Alamitos Energy Center

(13-AFC-01)

Data Responses, Set 6 (Response to Data Requests 83 to 168)

Submitted to
California Energy Commission

FIGURE DR160-1
Revised One-Line Diagram
Alamos Energy Center
Long Beach, California
October 2015

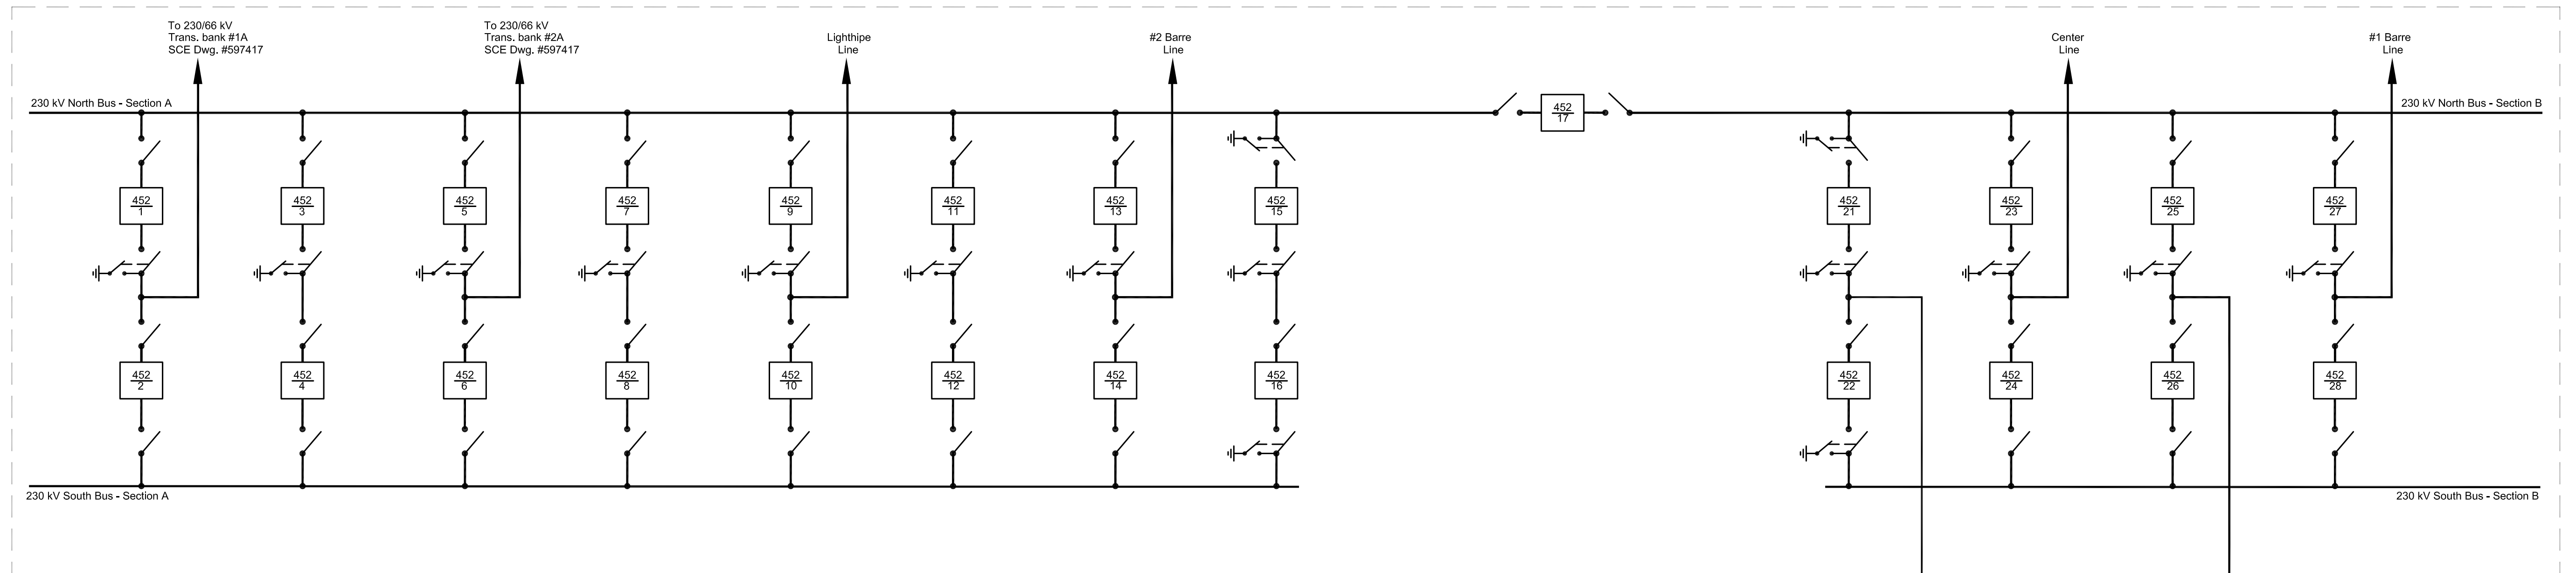
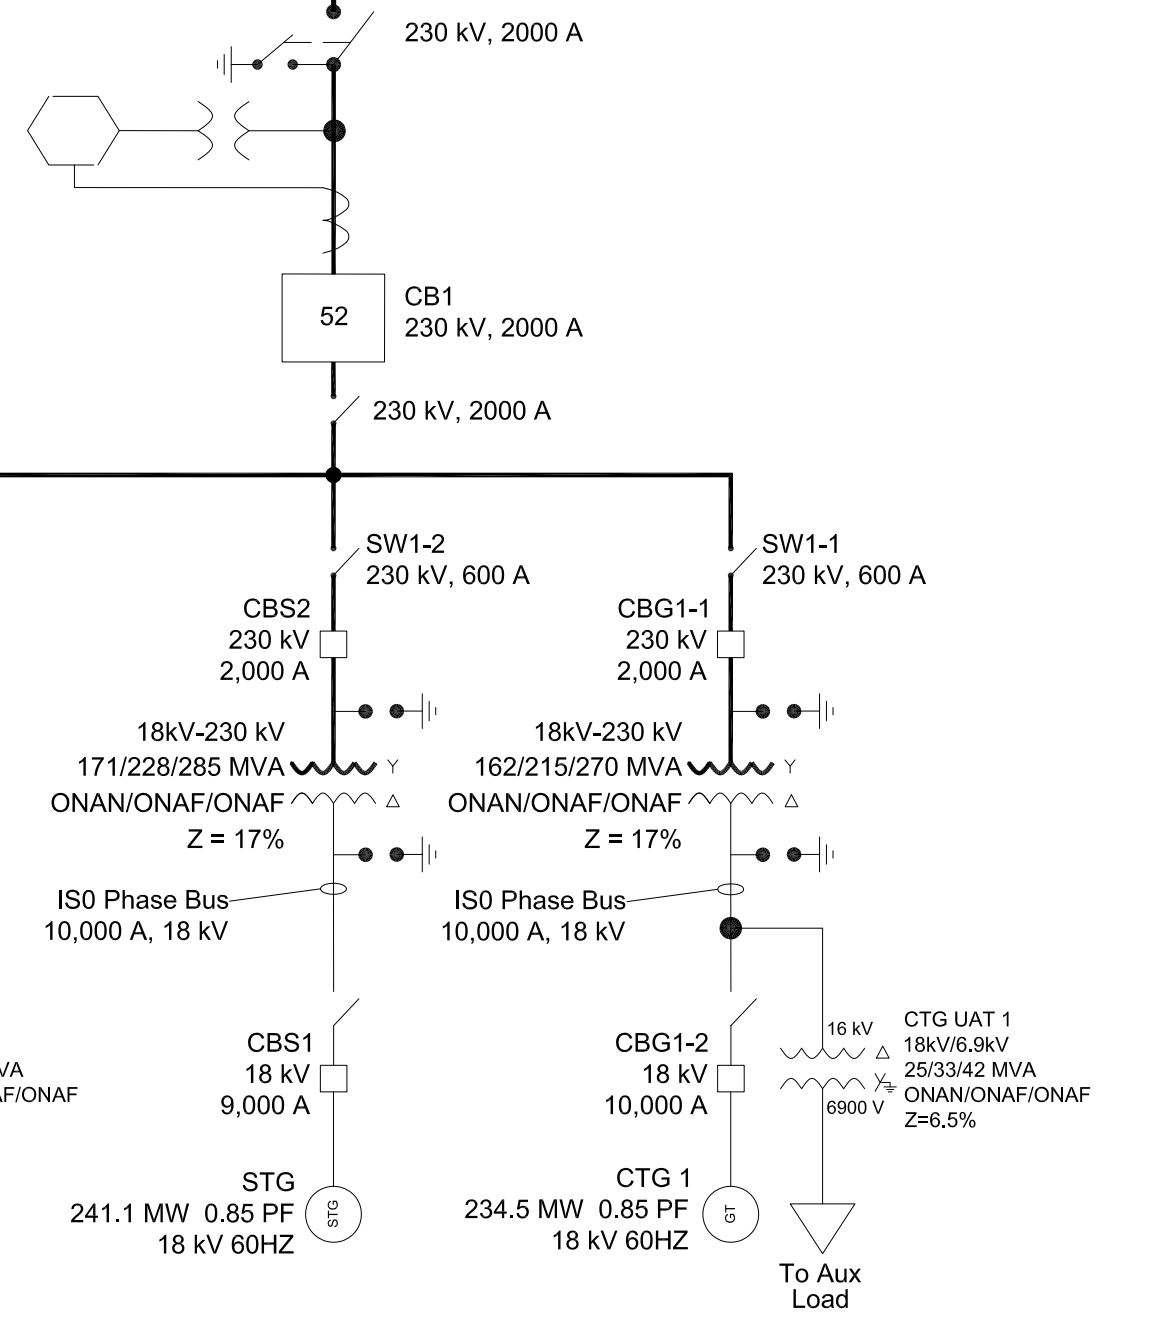
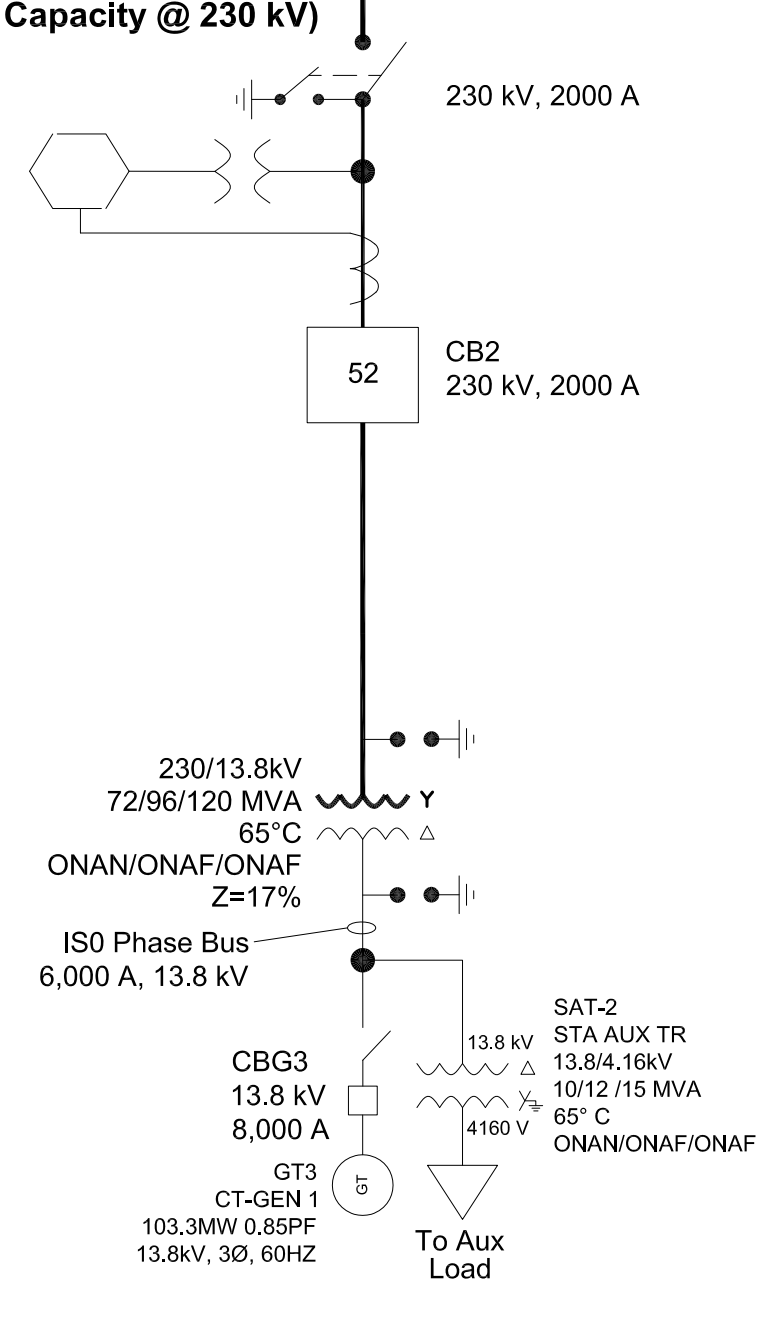
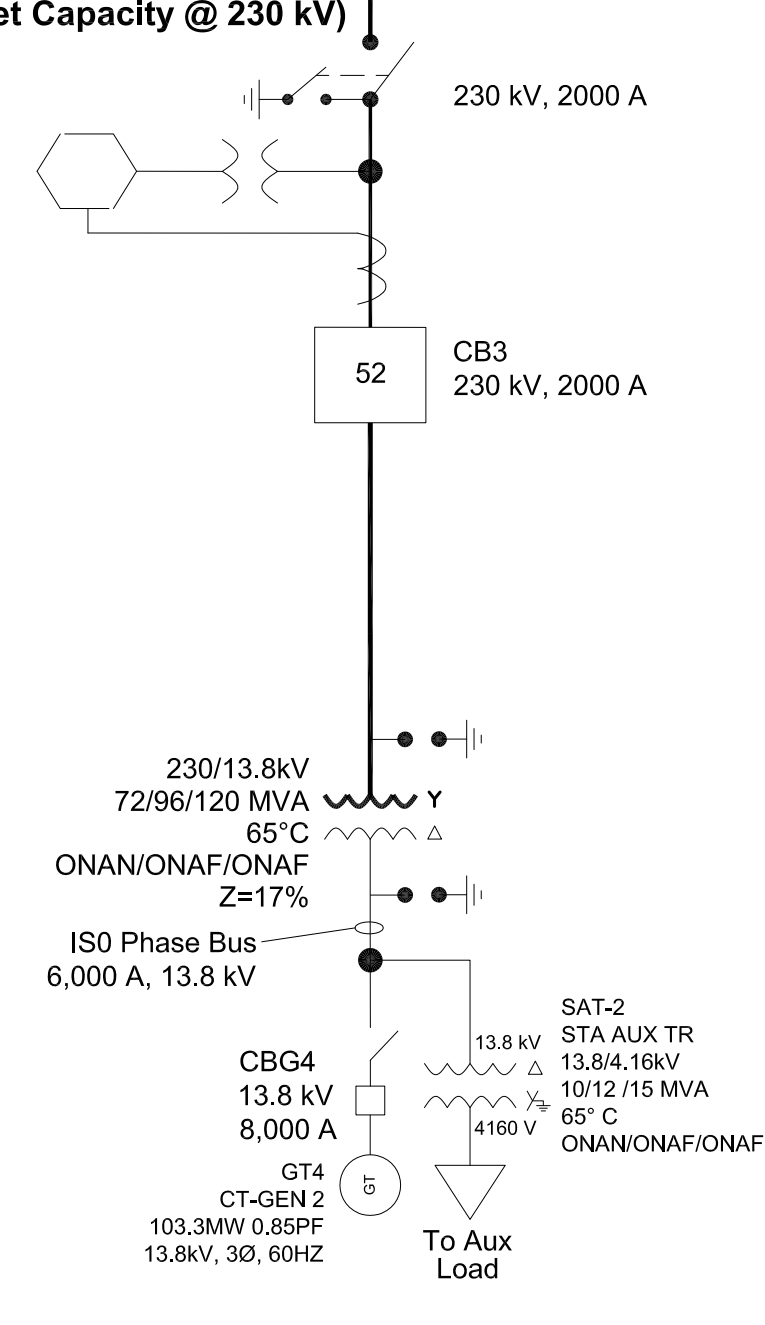
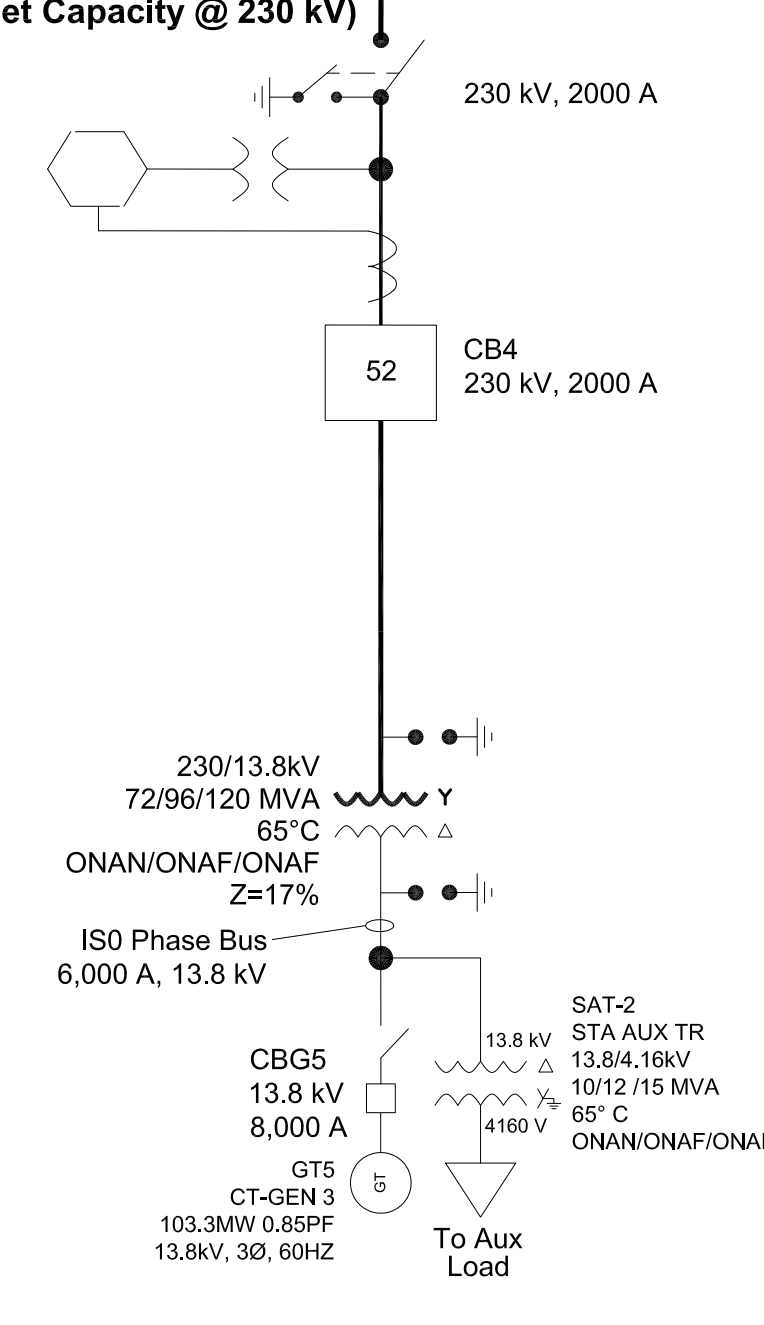
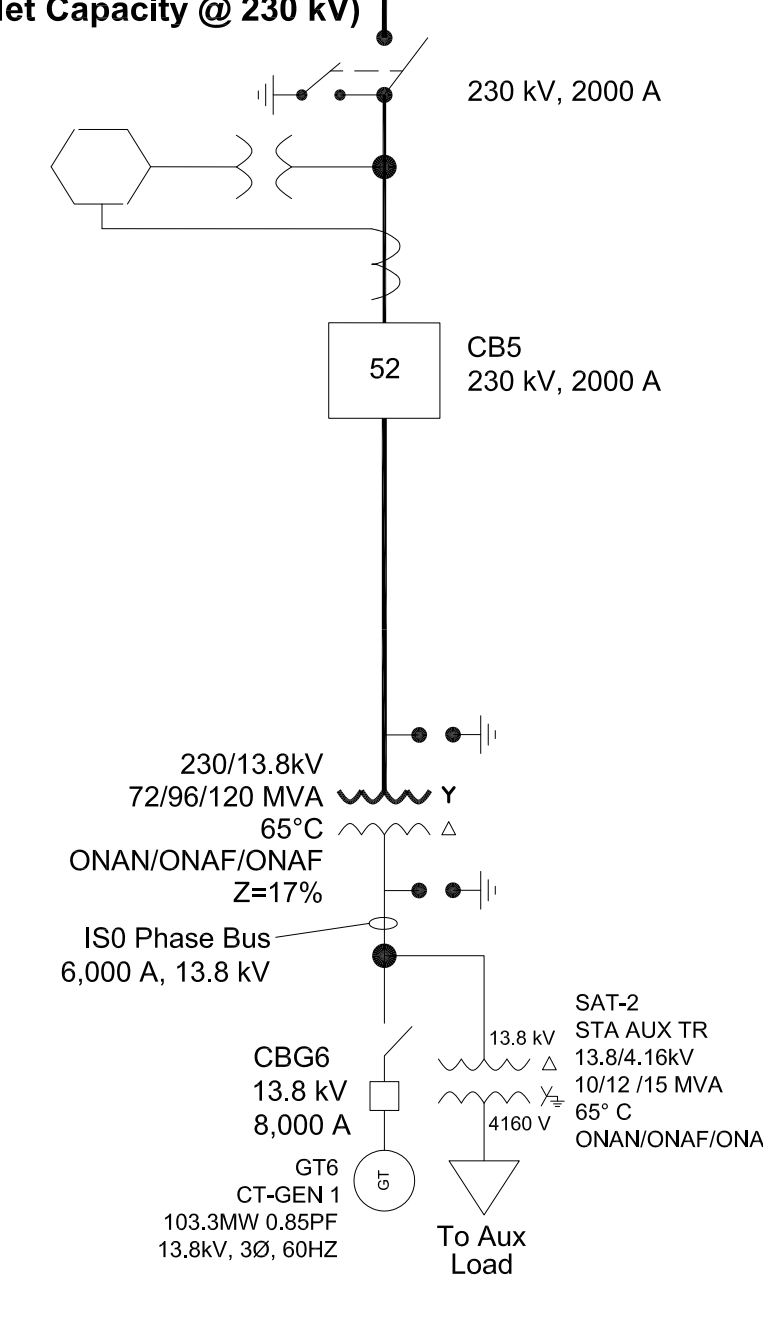
160. Resubmit the Electrical System One-Line Diagram, Figure 3.1-1, and provide a complete and labeled electrical one-line diagram of the proposed AEC switchyard showing the generators with their respective nominal MW ratings, and all equipment for each generator’s interconnection with the switchyard. The diagram should show:

Response: Figure DR160-1 presents a revised electrical system one-line diagram of the proposed AEC switchyard.

FIGURE 3.1-2R
Typical Transmission Tower Design
Alamitos Energy Center
Long Beach, California

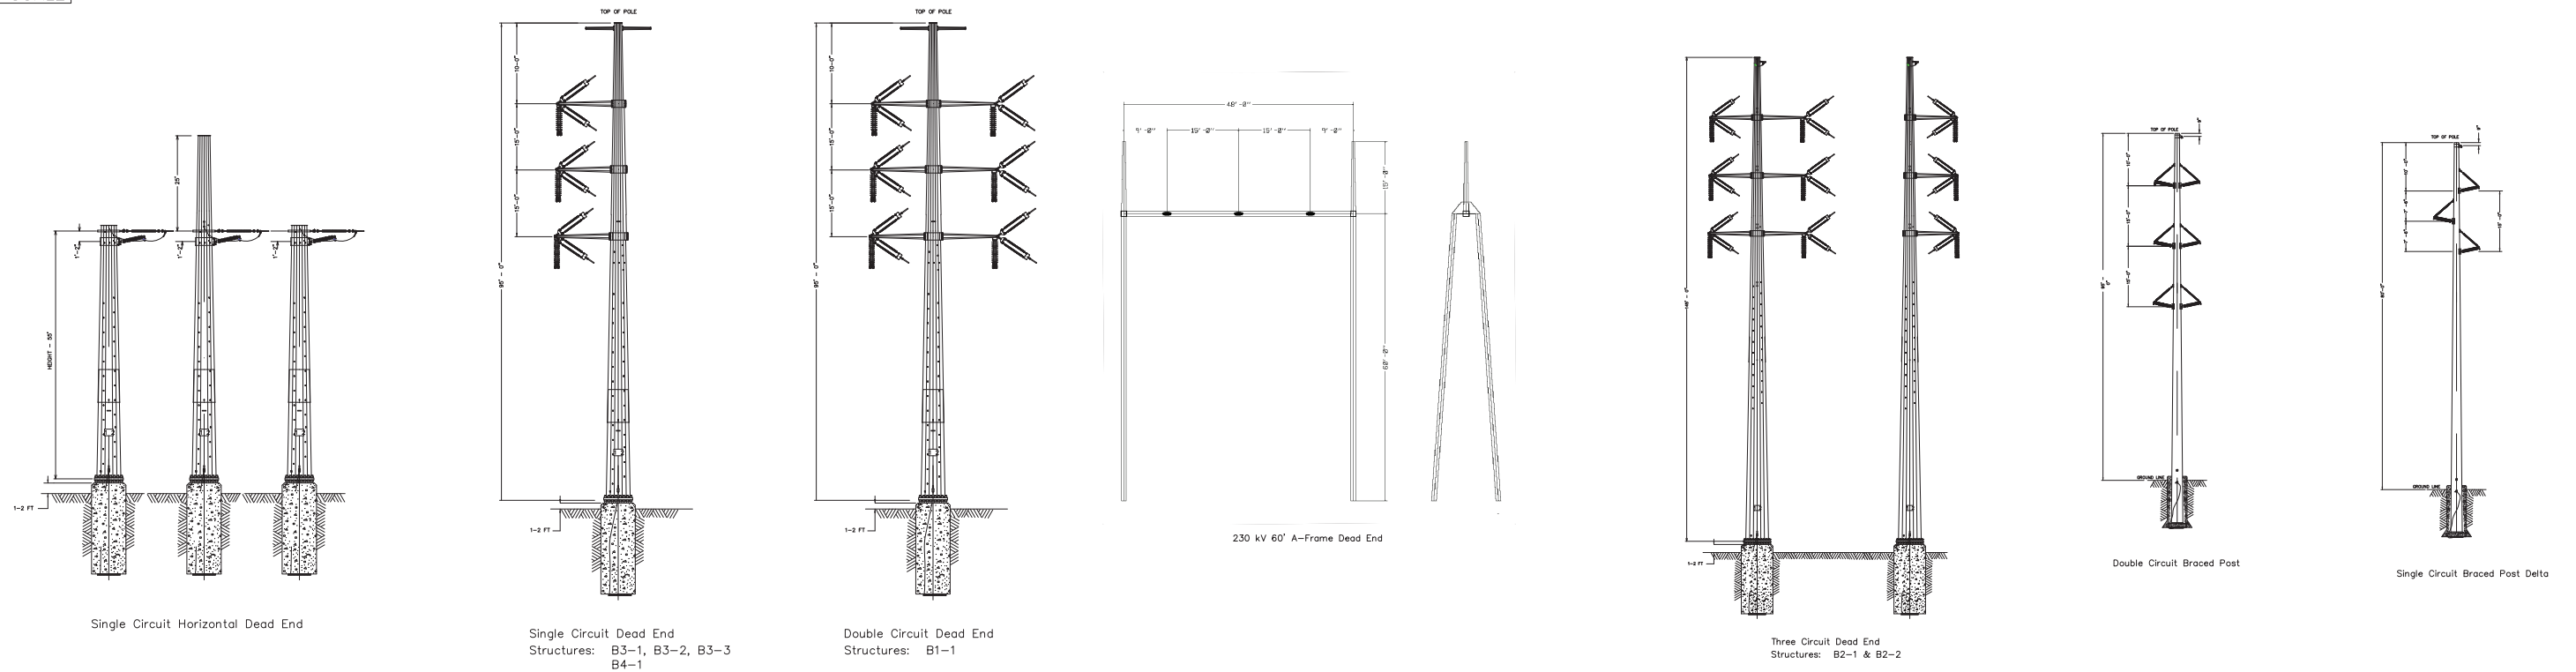
163. Refer to the Typical Transmission Tower Design Figure 3.1.2 and submit new, legible drawings of the transmission structures including dead- end and intermediate structures which will be used for construction of the two Gen Tie overhead lines.

Response: Figure 3.1-2R presents a legible drawing of the transmission structures, including dead-end and intermediate structures which will be used for construction of the two gen tie overhead lines.

FIGURE DR168-1
AEC Data Response Set #6
 Alamos Energy Center
 Long Beach, California
 December 2015

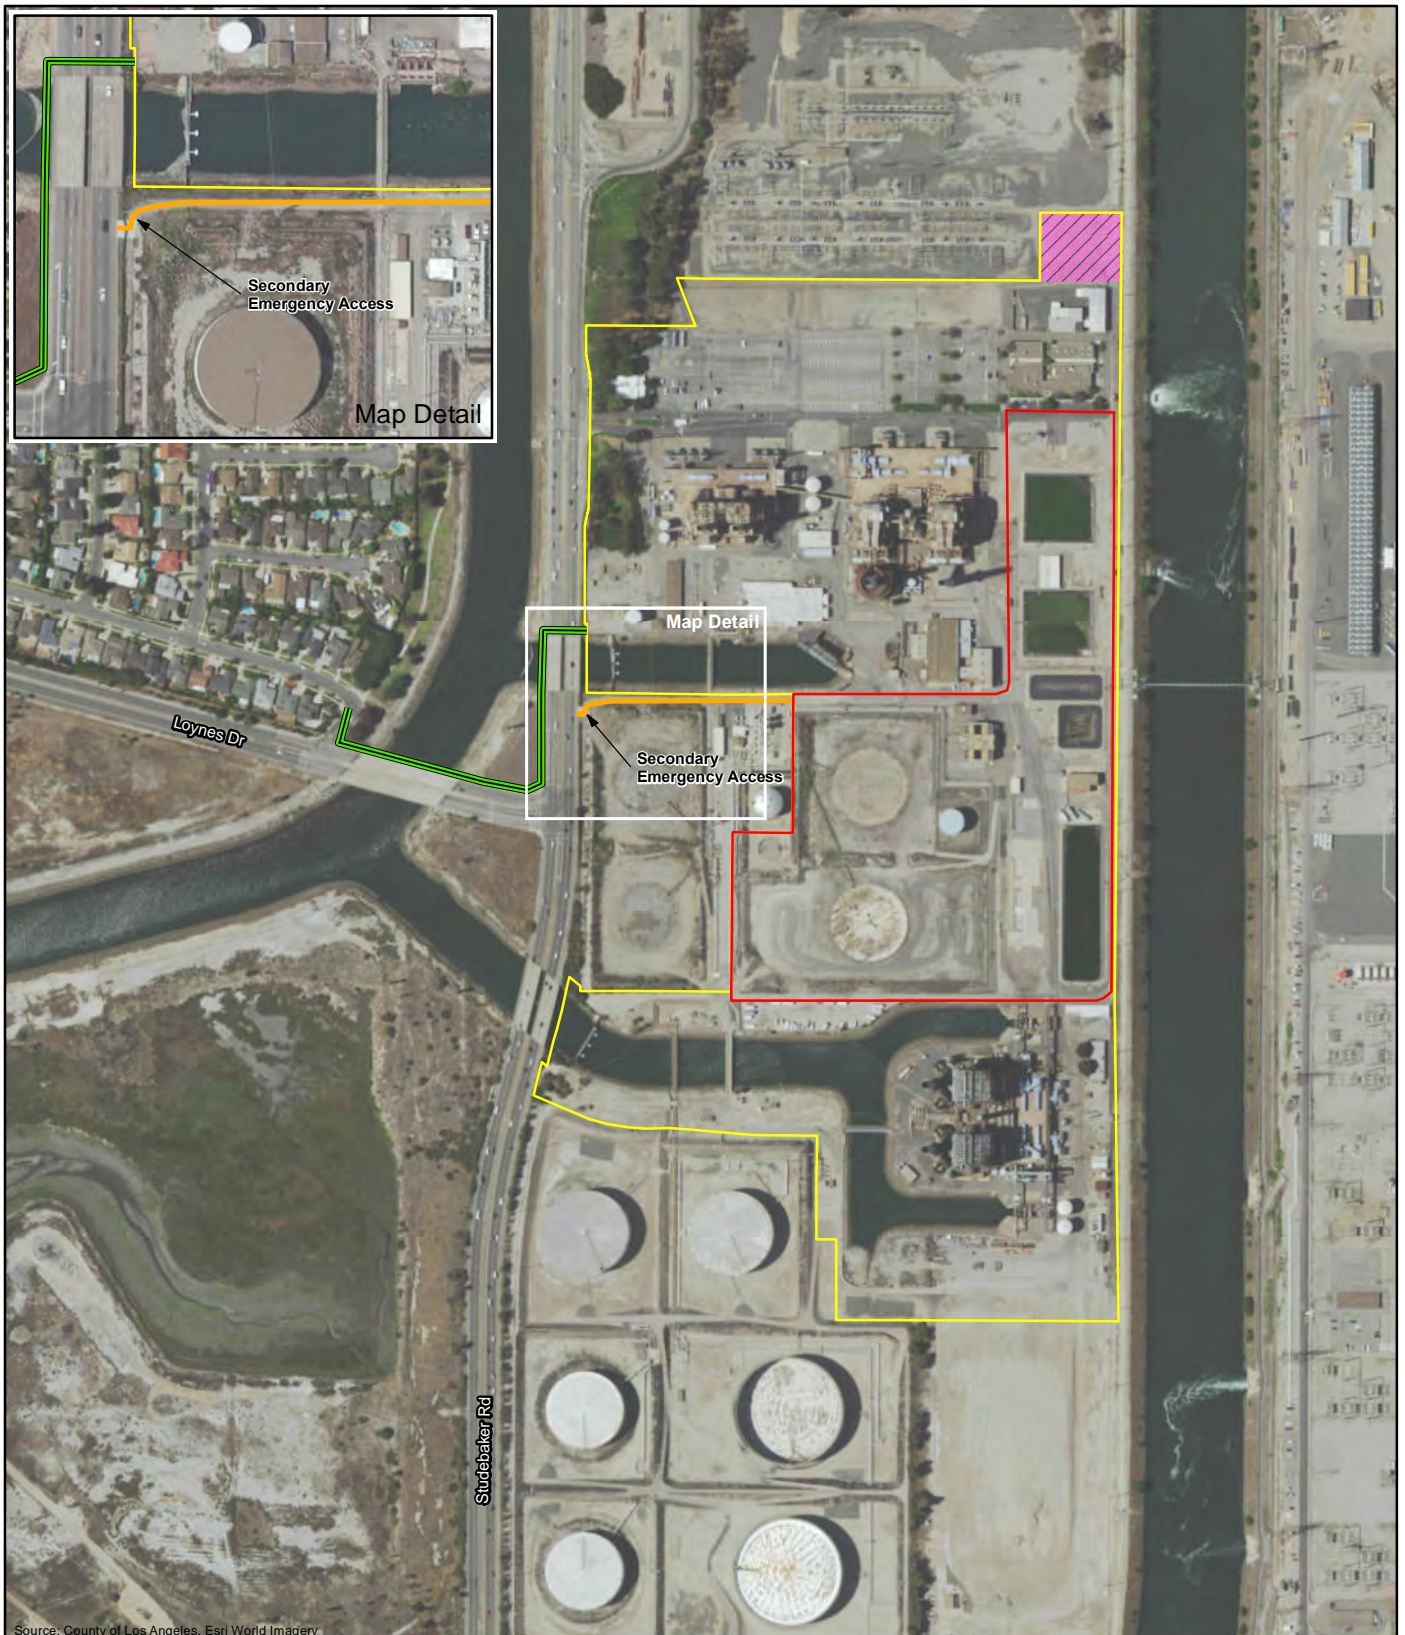
Except for the construction access road shown in Figure 2.1-1, the AFC does not address whether there will be a permanent secondary emergency access road to the site for possible use by emergency response services.

Response: A current emergency secondary access road exists off of Studebaker Road, just south of the northern intake water canal (see Figure DR168-1). This emergency access road has a locked gate and concrete aprons on the Studebaker Road and AGS project site. This secondary access road will be widened and upgraded for the AEC project.
